# Access Compliance Report

## Public Rights-of-Way

### (Curb Ramps)

Intersection ID: 24259	Main Street: HENSEY'S_WY	Cross Street: MIROW_PL	Location: W
ADA ID: A1188D32CC14	Ramp Type: PerpDiag	Initial Pass/Fail: Fail	Overall Compliance: No
Severity Score: 21.25			
Codes/Mitigation Info/Possible Solution		Field Measurements/Component Compliance

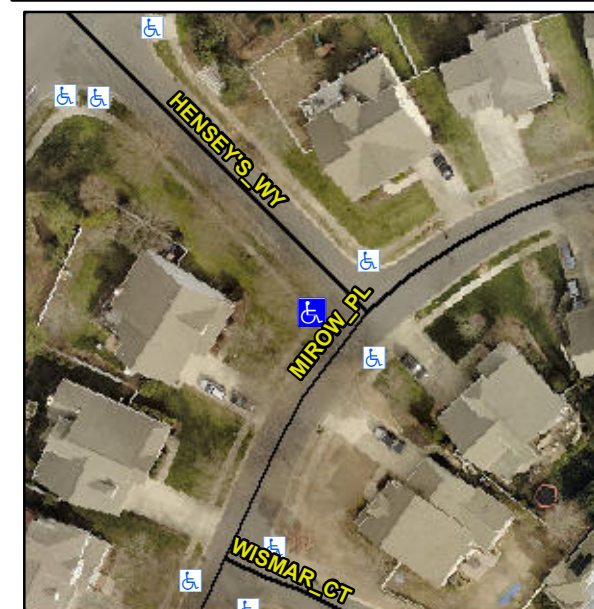
**Not Found, R304.5.1, R304.2.2**

Compliance	Description	Data	Compliance	Description	Data
N/A	Ramp Length (in)	47.0	No	Ramp Slope (%)	11.1
No	Ramp Width (in)	42.0	Yes	Ramp XSlope (%)	0.7
N/A	Flare Type LT	N/A	N/A	Flare Type RT	N/A
N/A	Flare Slope LT (%)	N/A	N/A	Flare Slope RT (%)	N/A
N/A	Flare Traversable LT?	N/A	N/A	Flare Traversable RT?	N/A
N/A	Landing Length (in)	N/A	N/A	DWS Provided?	N/A
N/A	Landing Width (in)	N/A	N/A	DWS Contrast?	N/A
N/A	Landing Slope (%)	N/A	N/A	DWS Length (in)	N/A
N/A	Landing X Slope (%)	N/A	N/A	DWS Full Width?	N/A
N/A	Landing Curb? (Y/N)	N/A	N/A	DWS Offset (in)	N/A
N/A	Shared Landing?	N/A			
N/A	Gutter Ponding?	N/A	N/A	Gutter Slope (%)	N/A
N/A	Gutter Lip Ht (in)	N/A	N/A	Gutter X Slope (%)	N/A
N/A	Painted X Walk1?	No	N/A	Painted X Walk2?	No
	X Walk 1 Direction	To NE		X Walk 2 Direction	To SE
N/A	X Walk 1 Width (in)	N/A	N/A	X Walk 2 Width (in)	N/A
	X Walk 1 Slope (%)	3.0		X Walk 2 Slope (%)	1.3
	X Walk 1 X Slope (%)	0.9		X Walk 2 X Slope (%)	2.5

**Remove & Replace Curb Ramp With Two New Directional Ramps or Equivalent.**
